September 21, 2000

Refer to: WZ-52

Thank you for your June 9, 2000 letter requesting Federal Highway Administration (FHWA) acceptance of your company's rigid plastic sign substrate for use with certain portable sign stands as crashworthy traffic control devices. Stands with the Reflexite EnduranceTM substrate are intended for use in work zones on the National Highway System (NHS). Accompanying your letter was a report from the Midwest Roadside Safety Facility, and videos of the crash tests. You requested that we find the listed devices acceptable for use on the NHS under the provisions of National Cooperative Highway Research Program (NCHRP) Report 350 "Recommended Procedures for the Safety Performance Evaluation of Highway Features."

Figure 1. System Nos. 1 and 2 Sign Support Details, Test FG-1

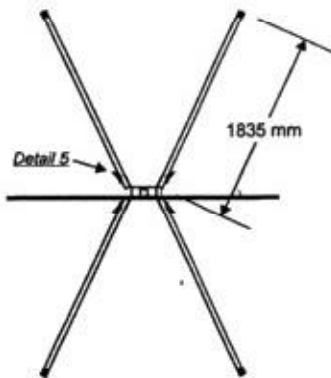
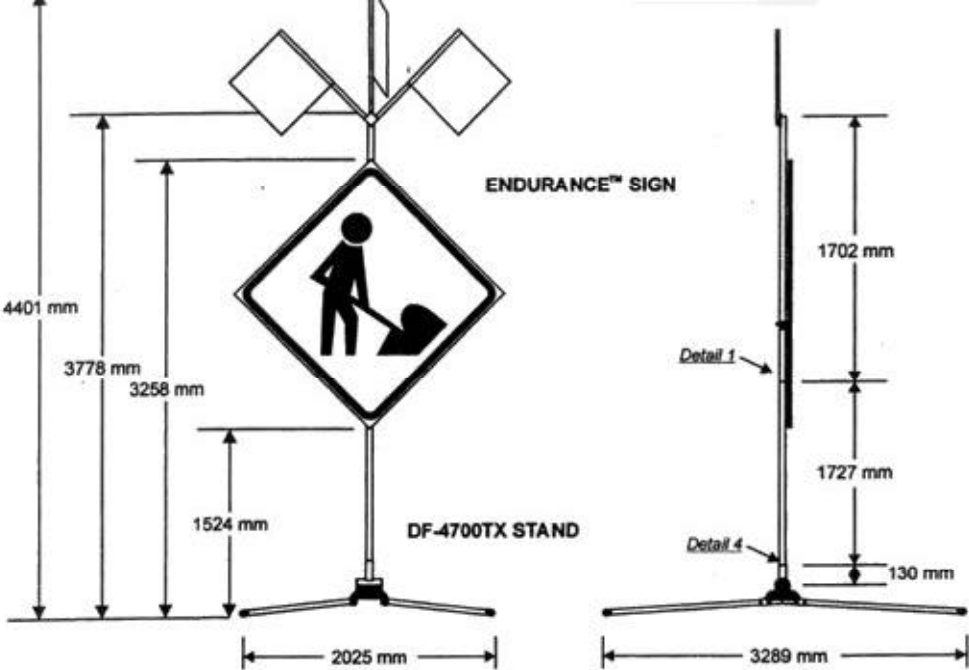
Damage to the vehicle was limited to scrapes to the hood, bumper, and roof, and minor to moderate cracking of the windshield. The test articles did not show potential for penetrating the occupant compartment. The results of this testing met the FHWA requirements and, therefore, the devices listed above and illustrated in Enclosure 1 are acceptable for use as Test Level 3 devices on the NHS under the range of conditions tested, when proposed by a state. In addition, Reflexite Endurance™ sign panels may be used on any other sign support, temporary or permanent, that has been successfully tested with conventional rigid aluminum (i.e. "0.080" thickness) or plywood signs. When used in permanent installations on breakaway supports, Endurance™ sign panels must be firmly fastened to the support in the same manner as other rigid sign substrates.
